ATTACHMENT FOUR A

PROPOSED TECHNICAL SPECIFICATION CHANGES

MARKED-UP PAGES

FIGURE 4.7-1
 SAMPLE PLAN 2) FOR SNUBBER FUNCTIONAL TEST

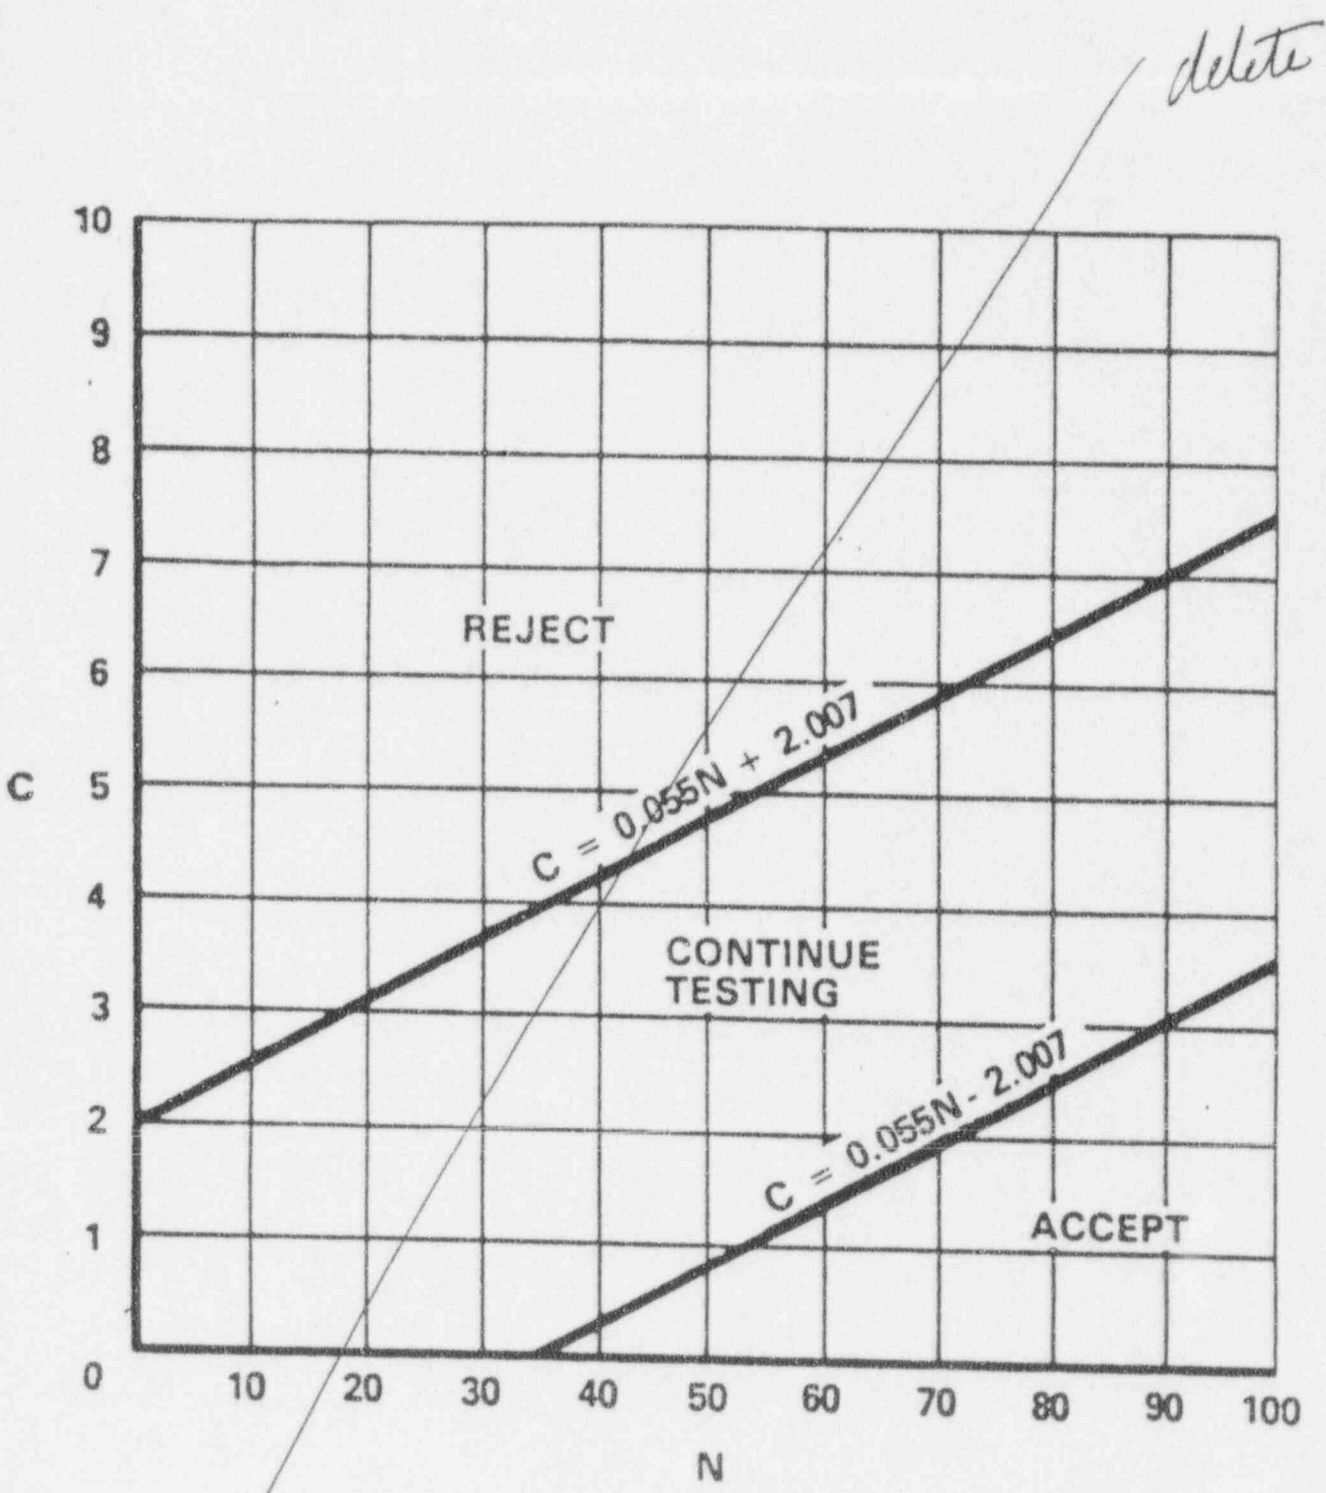
delete
